UNITED STATES PATENT AND TRADEMARK OFFICE

APPLICATION NO.	FILING DATE	FIRST NAMED INVENTOR	ATTORNEY DOCKET NO.	CONFIRMATION NO.
10/524,273	08/11/2005	Javier Marti Sendra	027318-00007	1001

Office Action Summary	Application No. 10/524,273	Applicant(s) MARTI SENDRA ET AL.	
	Examiner Omar Rojas	Art Unit 2874

DETAILED ACTION

In re claim 1, Kosaka discloses a system of coupling between a dielectric optical guide 13 and a planar photonic crystal guide 12, characterised by the fact that it consists of a coupling structure 11 necessary for adapting the width between both guides. Figure 2 of Kosaka is reproduced below.

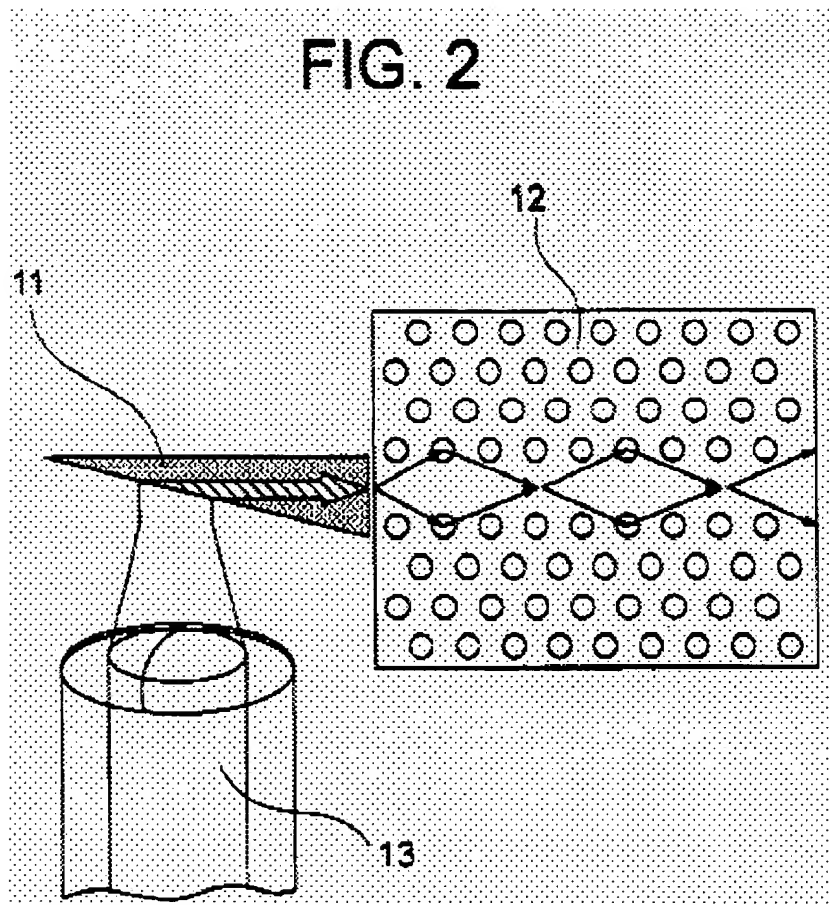
In re claim 2, the coupling structure 11 of Kosaka inherently has a length, width and shape, as seen in Figure 2, depending on the characteristics of both the dielectric guide 13 and the photonic crystal guide 12.

In re claim 3, the photonic crystal guide 12 of Kosaka inherently has a grid constant, radius and height of the cylinders and contrast of indices between the material of the columns, the material surrounding the columns and the material above and below the crystal as suggested by Figure 2.

Thus, Kosaka only differs from claims 1-5 in that Kosaka does not teach the introduction of point defects in the coupling structure 11 by selecting a particular number of defects and one or more defect characteristics including radius, dielectric constant, relative position and height as recited by claim 1.

Figure 17(a) of Dridi is reproduced below.

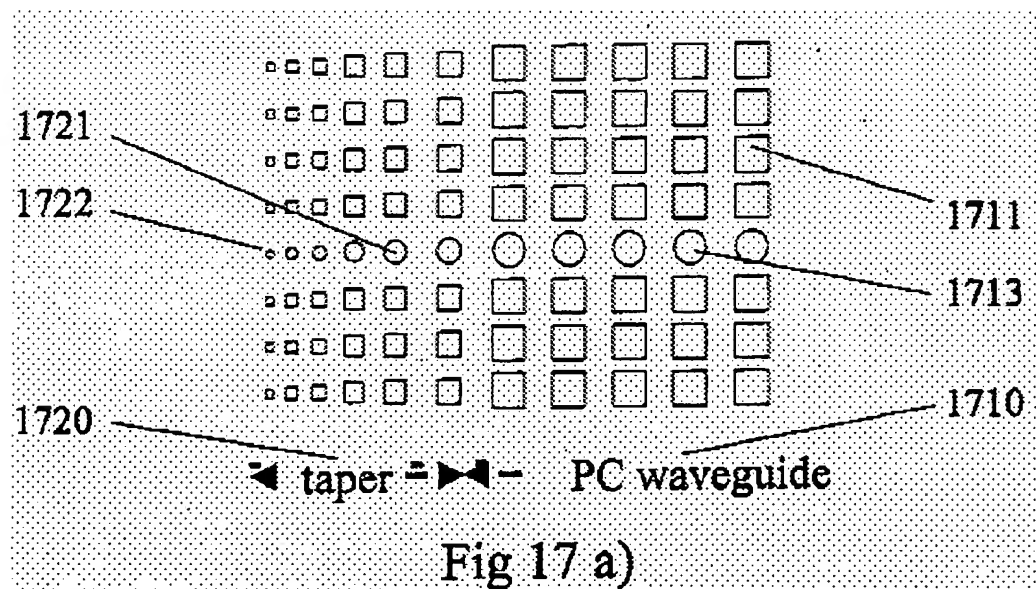
Dridi, on the hand, discloses introducing point defects 1721,1722 into a coupling structure (Figure 17) by selecting a particular number of defects and one or more defect characteristics including radius, dielectric constant, relative position and height. *See* Dridi at paragraph [0146].

The motivation for combining Dridi with Kosaka is to provide better low loss transfer of energy between the waveguides. *See* Dridi at paragraph [0047]. Therefore, it would have been obvious to one of ordinary skill in the art at the time of the claimed invention to obtain the invention specified by claims 1-5 in view of Kosaka combined with Dridi.

In re claim 6, an optimum number of defects 1721, 1722 is inherently chosen in Dridi as well as the characteristics of each one of them, both for introducing the light from a dielectric guide into a photonic crystal guide as for extracting the light from a photonic crystal guide into a dielectric guide because Dridi teaches low loss adiabatic transfer of energy between waveguides. *See* Dridi at paragraph [0047]. Therefore, it would have been obvious to one of ordinary skill in the art at the time of the claimed invention to obtain the invention specified by claim 6 in view of Kosaka combined with Dridi for the same reasons given with respect to claims 1-5.
